Product Update Memo

INDUCTIVE COMPONENTS

February, 2006

Bourns® Inductive Components Product Line Announces PT121xxSL Series to Replace PT121xxL Series on May 1, 2006

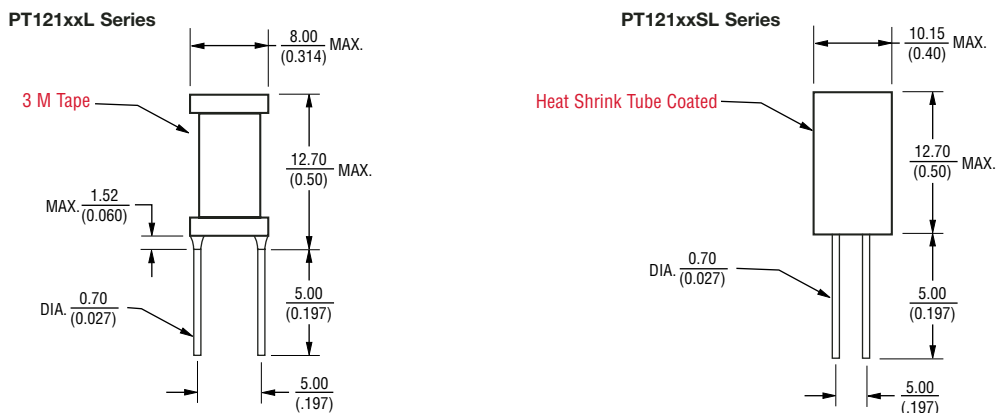
As of May 1, 2006, the PT121xxSL will be the only version of Model PT121 that will be available. The electrical properties of the PT121xxSL series are IDENTICAL to those of the PT121xxL series. The diameter of the PT121xxSL (10.15 mm) is a maximum of 2.15 mm greater than the diameter of the PT121xxL (8.00 mm). Outline drawings of the two series are shown below.

The PT121xxSL version has shrink-tube around the entire core, top-to-bottom, and covers the winding. The shrink-tube provides more support for the leads by enclosing them in the notches of the core.
